Tennessee Valley Authority, 1101 Market Street, Chattanooga, TN 37402

CNL-17-055

Clinch River Nuclear Site
NRC Docket No. 52-047

Subject: Submittal of Supplemental Information Related to the Exclusion Area Boundary and Population Distribution Around the Clinch River Nuclear Site in Support of the Early Site Permit Application

SSAR Figure 2.1-5 is being replaced with the figure below.

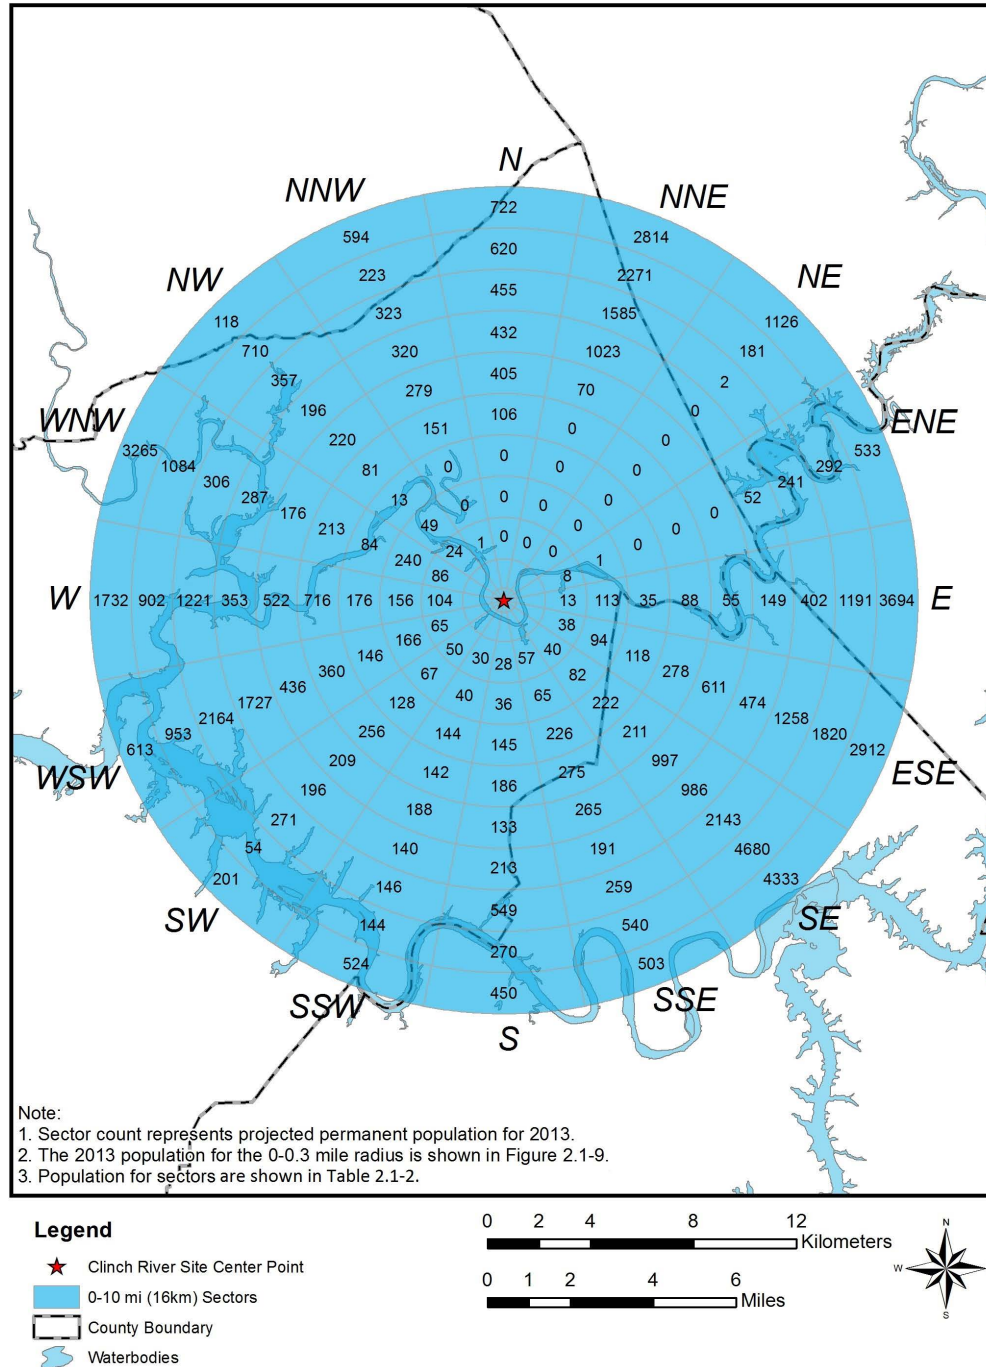
During identification of the above changes, it was determined that the ESPA does not clearly describe that the EAB and the CRN Property boundary are the same as the owner controlled area boundary. Therefore, SSAR Subsections 2.1.1 and 2.1.2 (including Figure 2.1-5) are being revised to provide this clarification.

The exclusion area boundary (EAB) is delineated by the boundary of the CRN Property, as shown on Figure 2.1-5.

SSAR Figure 2.1-6 is being replaced with the figure below.

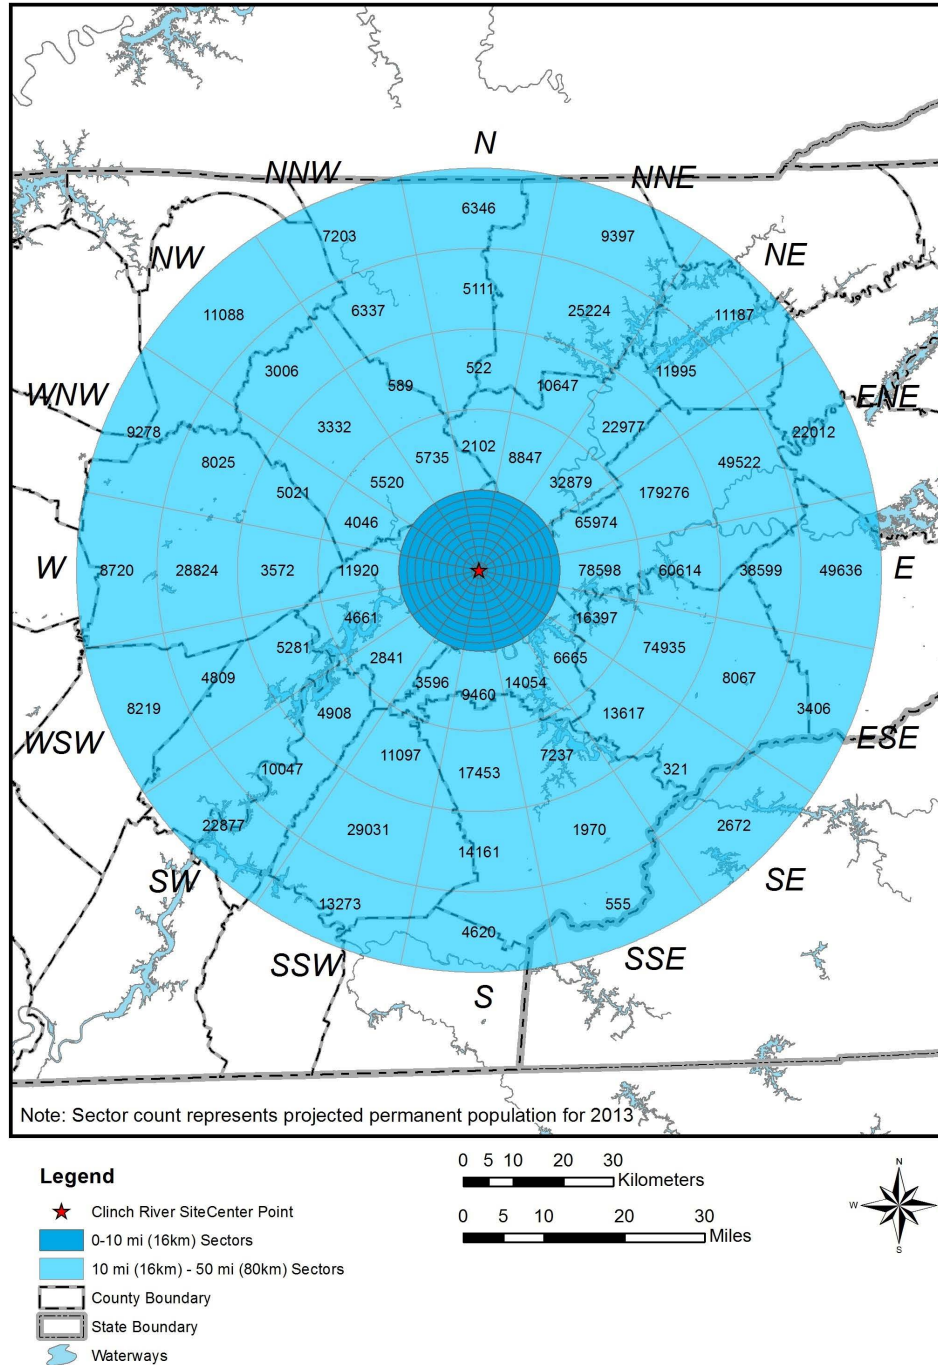
Regarding population distributions with respect to the EAB, SSAR Table 2.1-2 is being revised and a new figure (SSAR Figure 2.1-9) is being added to clarify the population distribution in and around the EAB. SSAR Section 2.1.3 and SSAR Figure 2.1-6 are being revised to refer to the new figure. In addition, SSAR Figure 2.1-7 is being revised to remove an erroneous reference citation. Similar changes are being made with the revision of ER Table 2.5.1-2 and the addition of new Figure 2.5.1-3. ER Subsection 2.5.1 and ER Figure 2.5.1-1 are being revised to refer to the new ER Figure 2.5.1-3.

Figure 2.3.4-1. Effluent Release Boundary with Analytical EABs

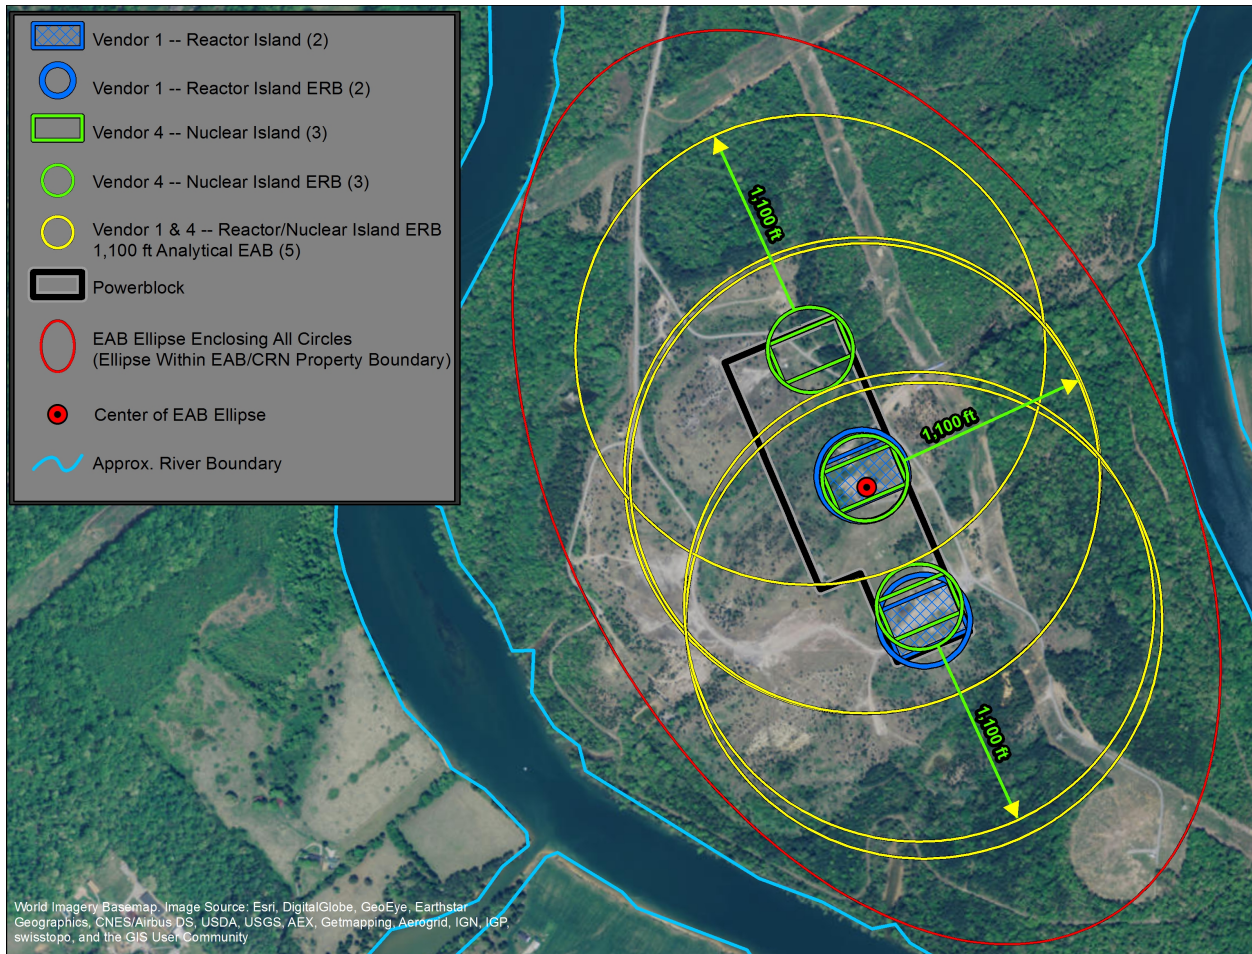
Therefore, SSAR Subsection 2.3.4 (including Tables 2.3.4-10, 2.3.4-11, 2.3.4-12, and 2.3.4-14, and Figures 2.3.4-1 and 2.3.4-2) and Subsection 2.3.5 (including Tables 2.3.5-1, 2.3.5-2, 2.3.5-3, and 2.3.5-10, and Figure 2.3.5-2) are being revised to more consistently use the terms associated with the analytical EAB when referring to analysis methodology or results. Similarly, ER Subsection 2.7.5 (including Tables 2.7.5-11, 2.7.5-12, and 2.7.5-13, and Figures 2.7.5-1 and 2.7.5-2) and Subsection 2.7.6 (including Tables 2.7.6-1, 2.7.6-2, 2.7.6-3, and 2.7.6-10, and

The site center point is determined as the centerline midpoint of the EAB ellipse (Figure 2.3.4-1). The ellipse has a short axis of 0.326 mi (524 m) from the site center point and long axis of 0.535 mi (864 m) from the center point.

Figure 2.7.5-2. Effluent Release Boundaries (ERBs), Analytical EAB, and Site EAB

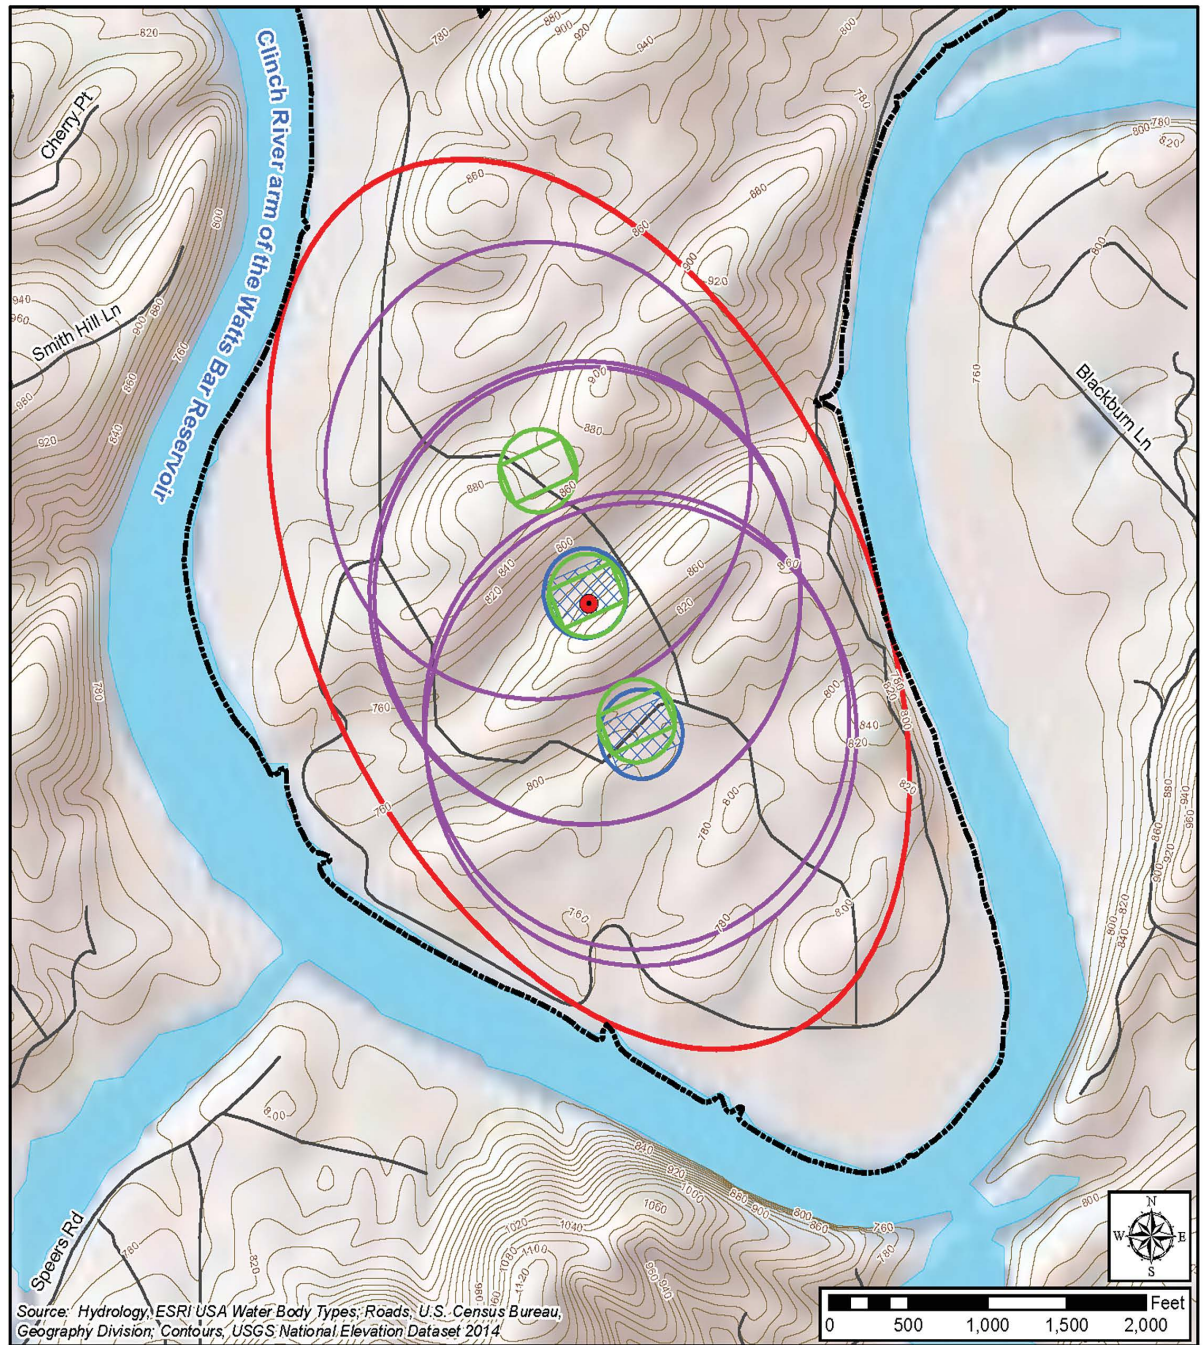
The site center point is determined as the centerline midpoint of the EAB ellipse (Figure 2.7.5-2). The ellipse has a short axis of 0.326 mi (524 m) from the site center point and long axis of 0.535 mi (864 m) from the center point. a circular, analytical EAB was defined at a fixed distance from the release zone. The release zone was based on circular effluent release boundaries (ERBs) that were determined as a composite of the proposed reactor and engineering structures that bound the safety and environmental impact of facility construction and operation on the CRN Site. The ERBs also allow for any future changes in the CR-SMR-Project's footprint. The ERBs encompassed the nuclear island from the largest two SMR-sources of potential vendors (Figure 2.7.5-1).

The CRN Site center point for the PAVAN modeling was determined by finding the midpoint of a centerline of an ellipse that enveloped the release zone ERBs (Figure 2.7.5-2).

Figure 2.7.6-2. LPZ and analytical EAB distances used for the Complex Terrain Analysis

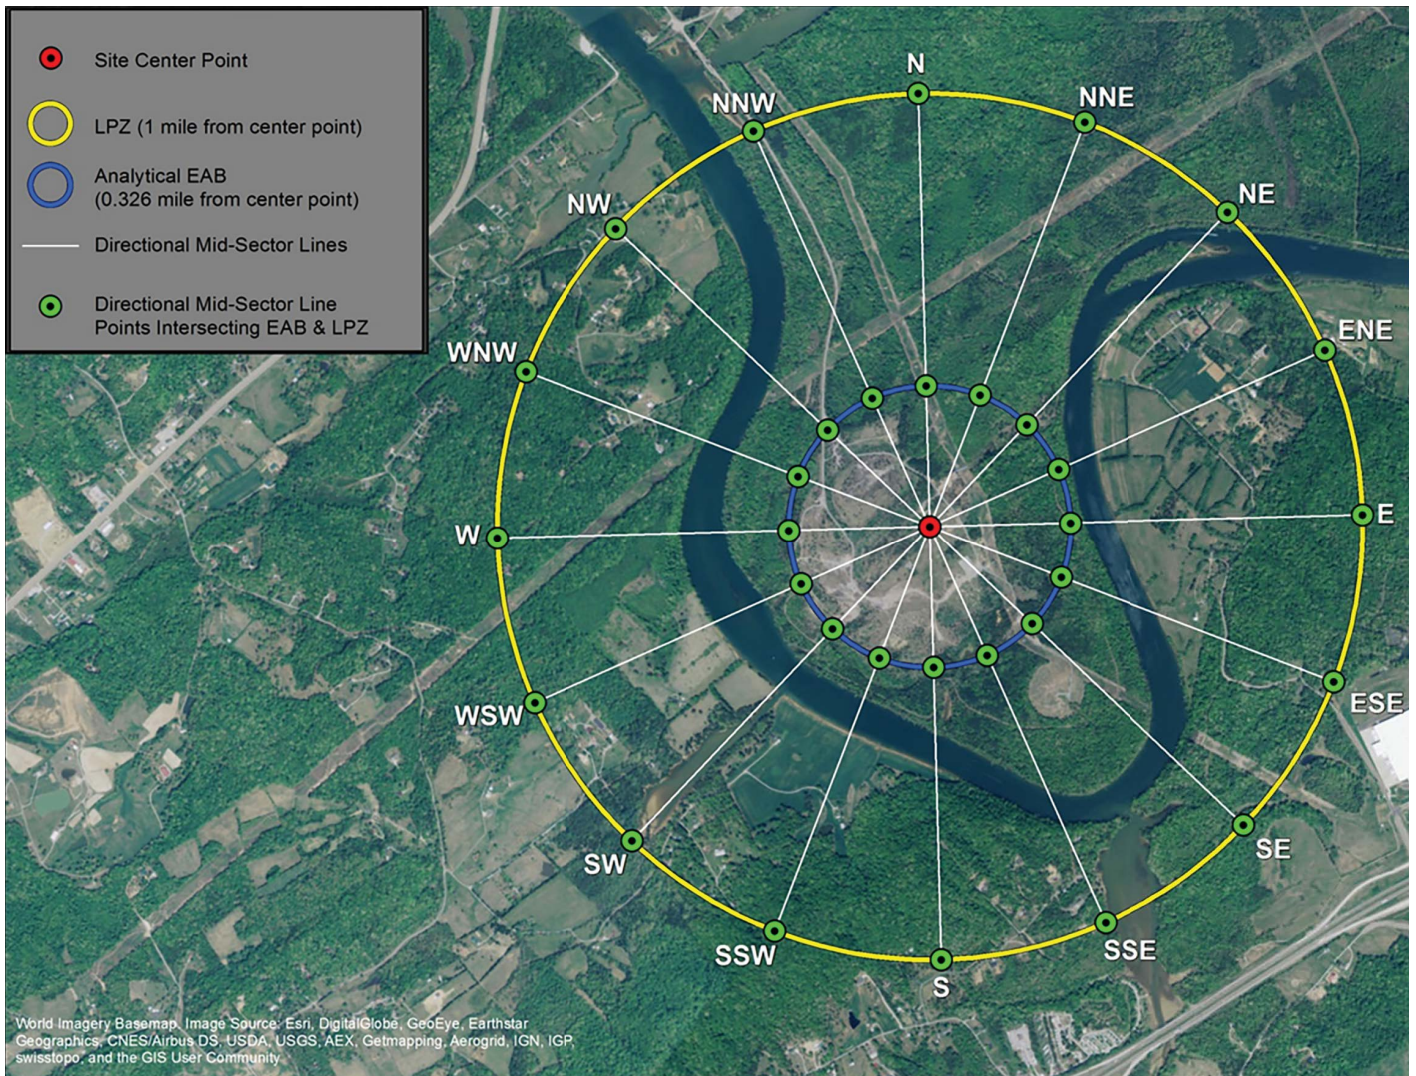
Figure 2.7.6-2) are being revised to more consistently use the terms associated with the analytical EAB.
